SD-2024-1745 Silver Run Road

Preliminary Plat: 44 lots

Project Number	20241745
Project Name	Silver Run Subdivision
Location	603 Silver Run Road
Stage	Sketch Plan
Parcel(s)	0006-00-034.00
Status	Not Approved

Subject: Silver Run Subdivision Preliminary Plat Submittal
CEC Project 343-968

STORMWATER MANAGEMENT ANALYSIS	
DATE:	JUNE 2024
DWG SCALE:	AS SHOWN
PROJECT NO:	343-968
APPROVED BY:	MILG
STAFF:	MEK
DRAWN BY:	343-968
CHECKED BY:

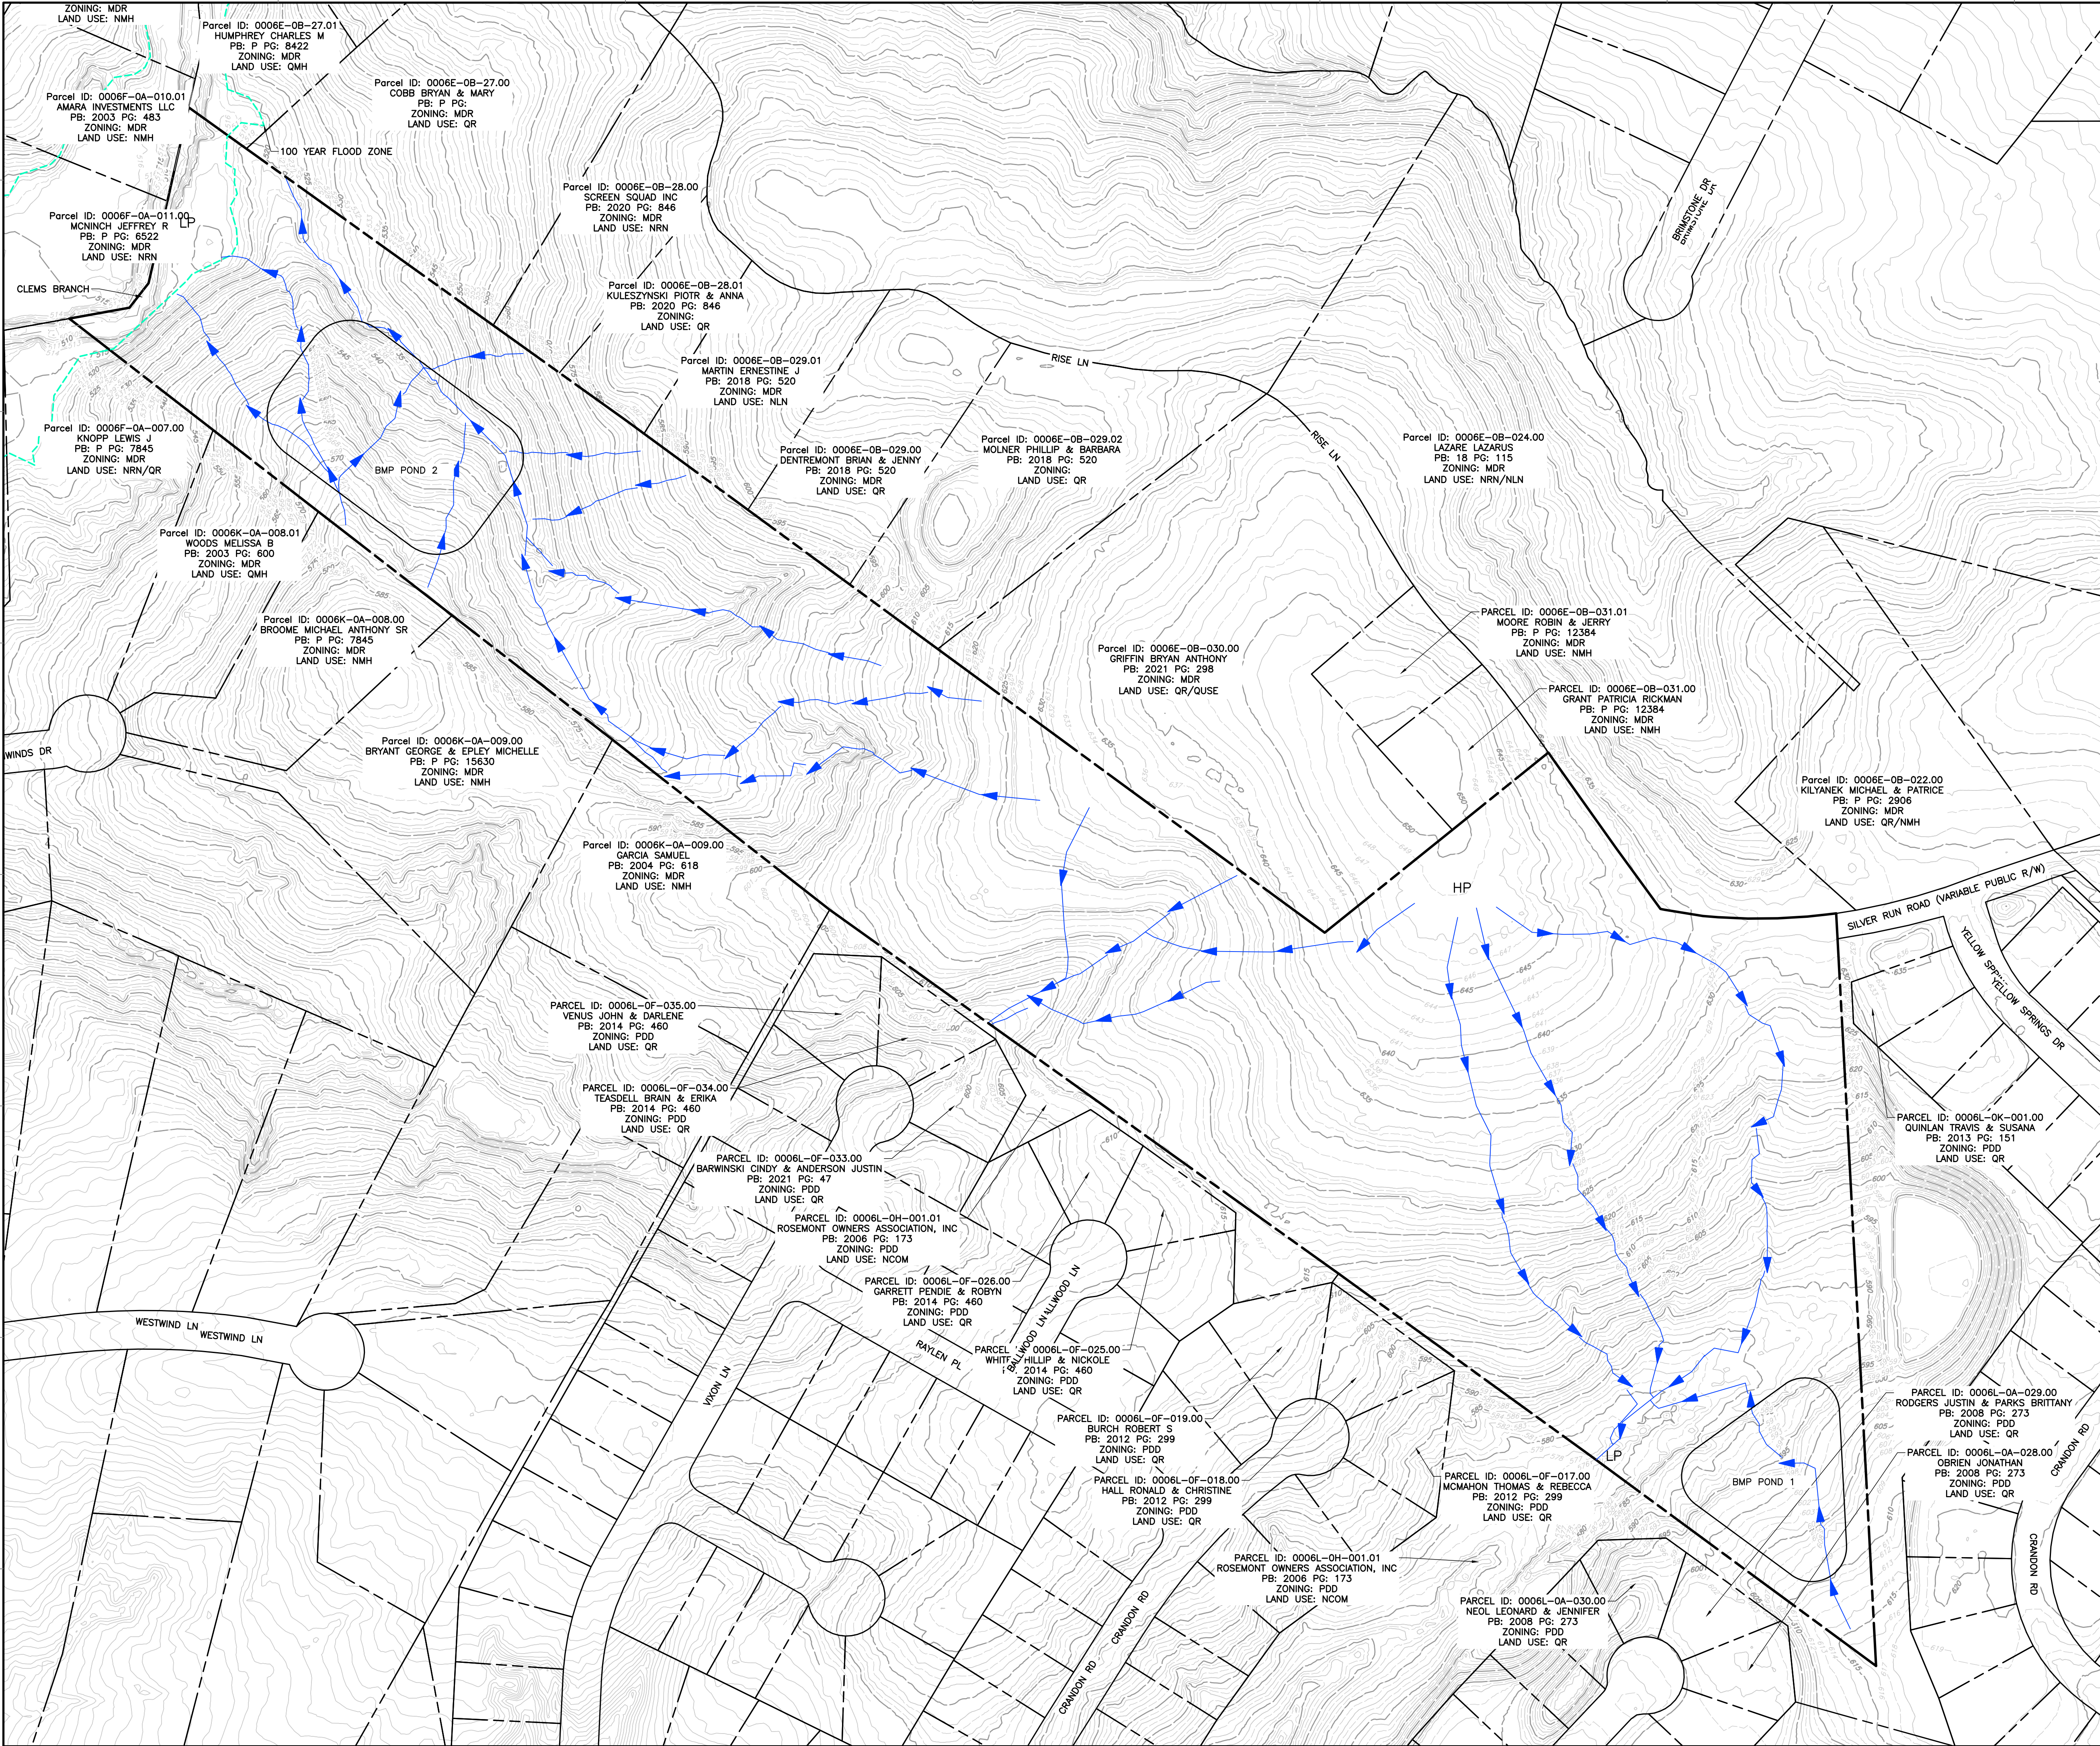
4. The BMP ponds will need to have an access area at least 10 feet wide at not greater than a 4(H) to 1(V) slope to the bottom of the pond. This is for maintenance of the pond during and after construction. This appears to not be an issue with the pond location proposed.

SKETCH PLAN

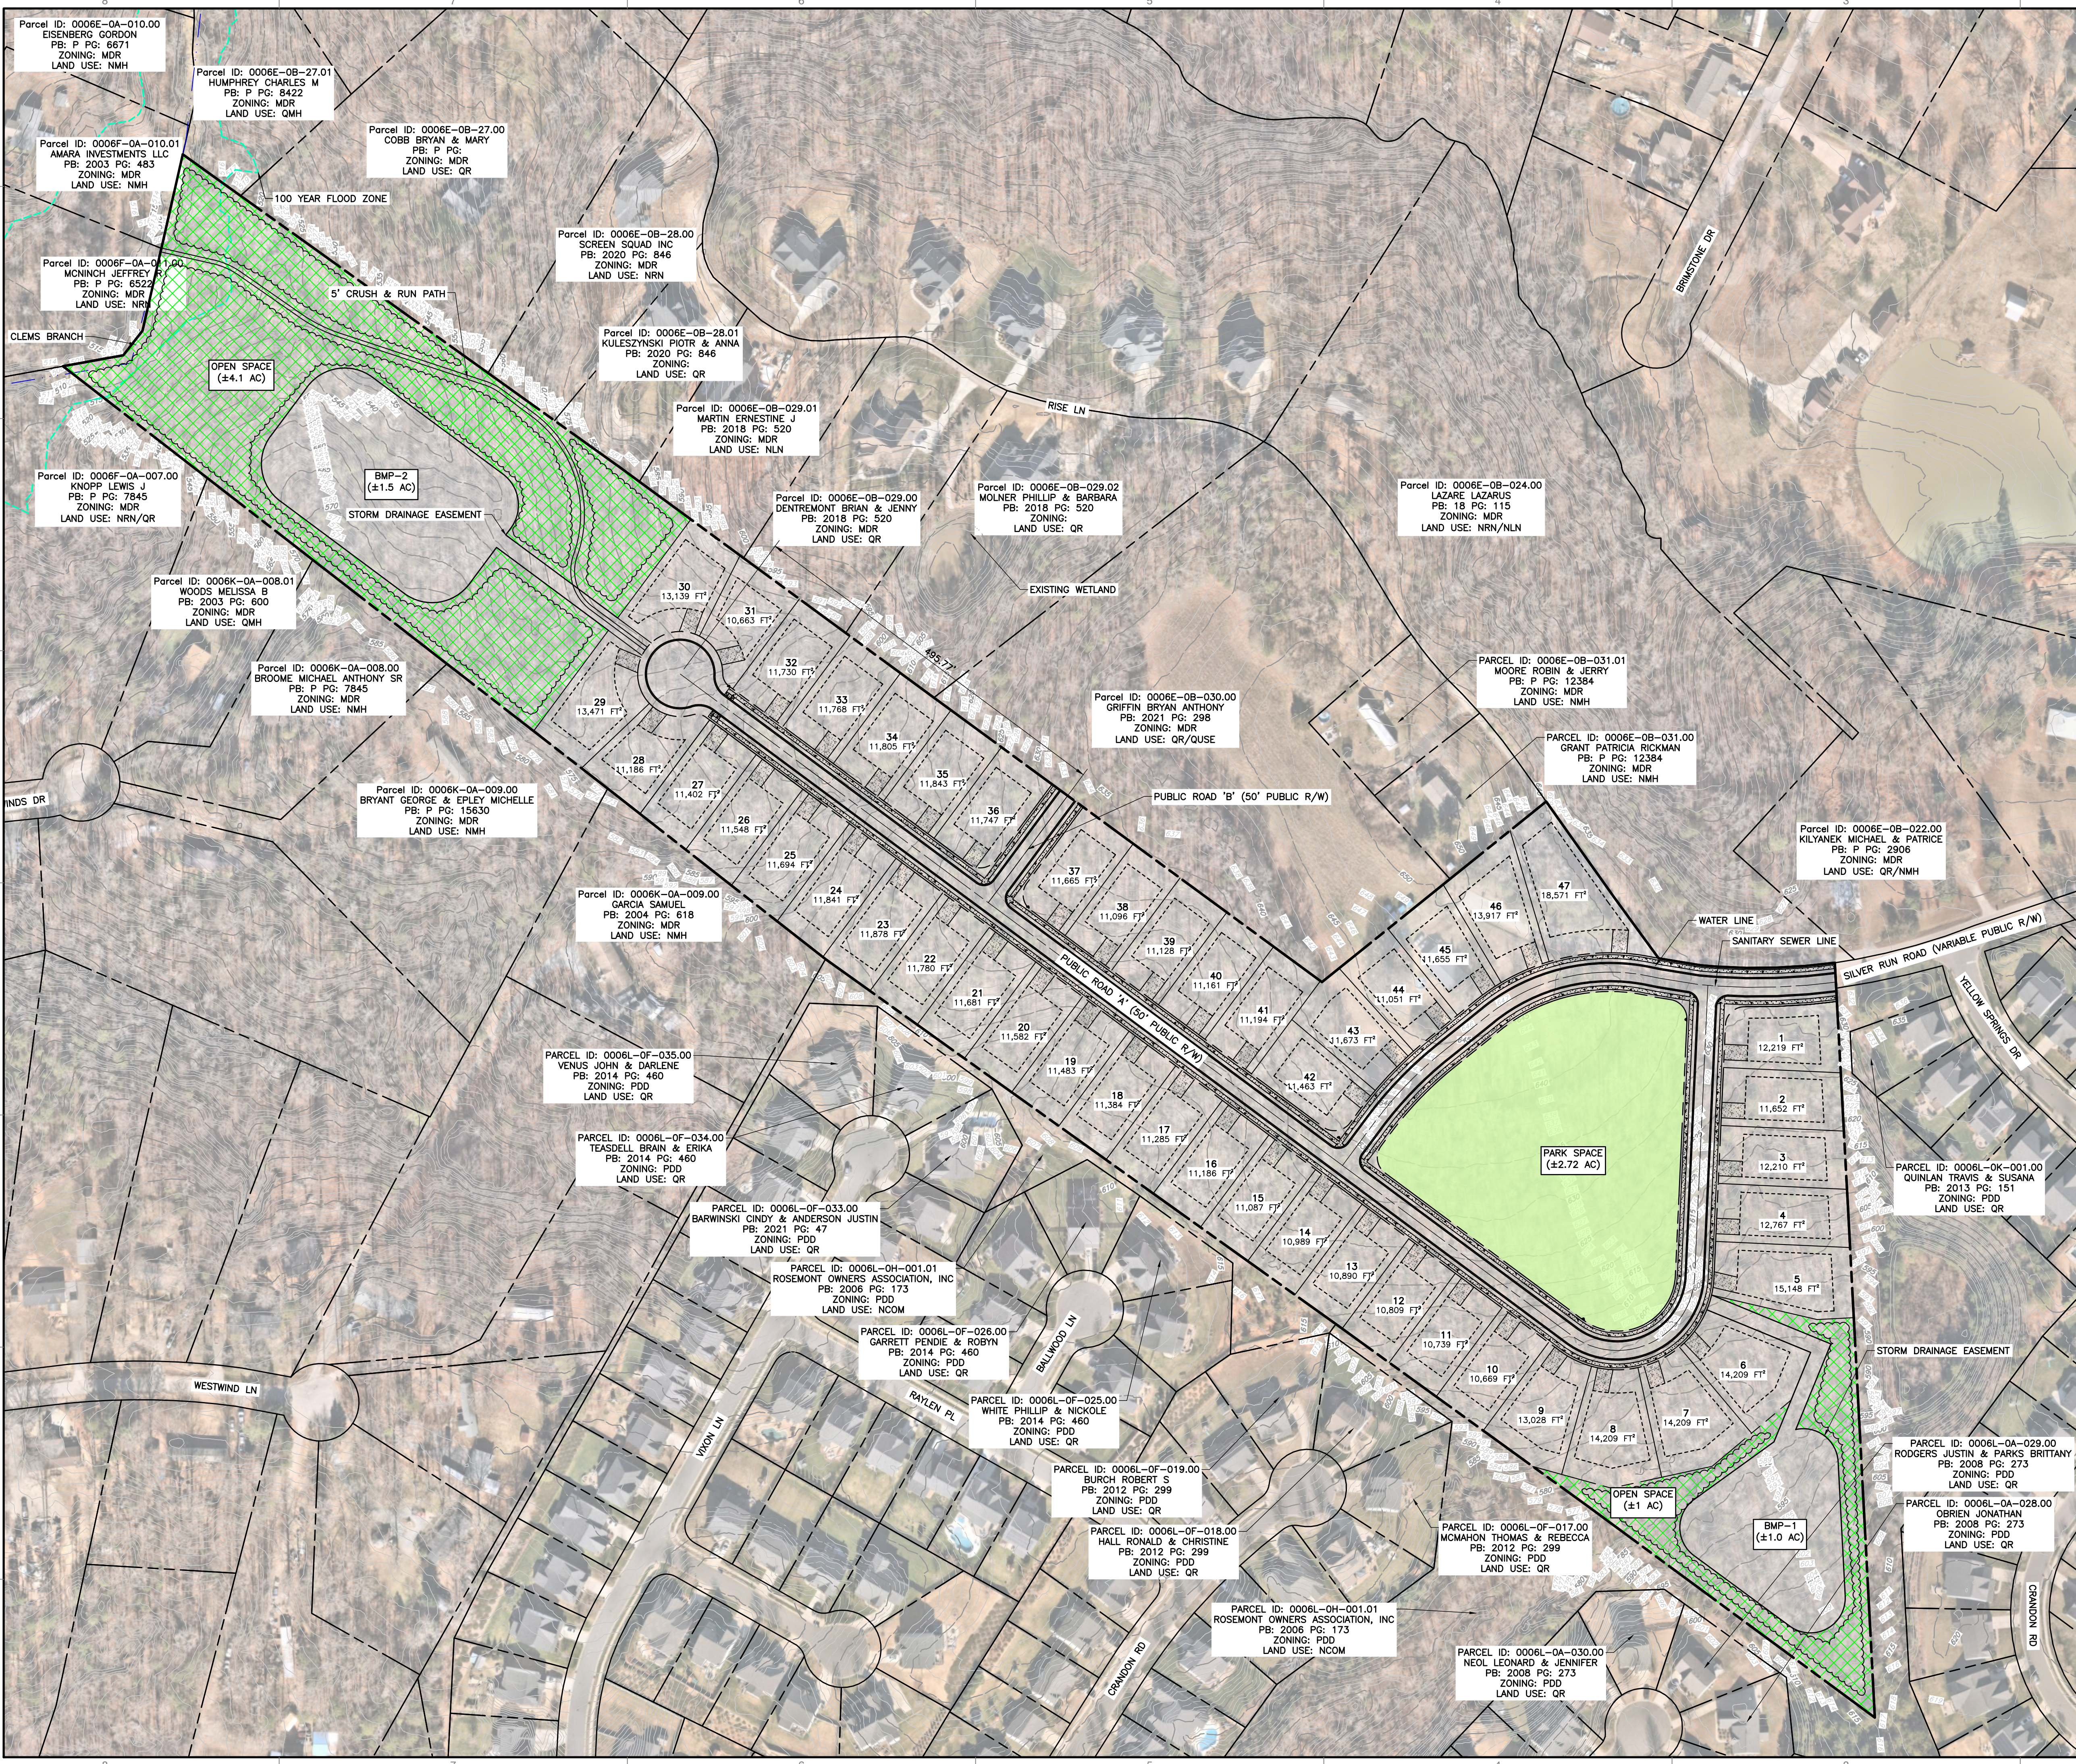
Permanent barricades shall be provided at the end of all street stubs (UDO 6.4.2.A.2).

Please depict curb ramps on your next submittal (UDO 6.6.4)

Please ensure that the required open space is not within the BMP or floodplain. This must be in a usable area of the site.

I am concerned for the distance between the driveway for lot 1 and the intersection at Silver Run Road. This distance is only 62ft
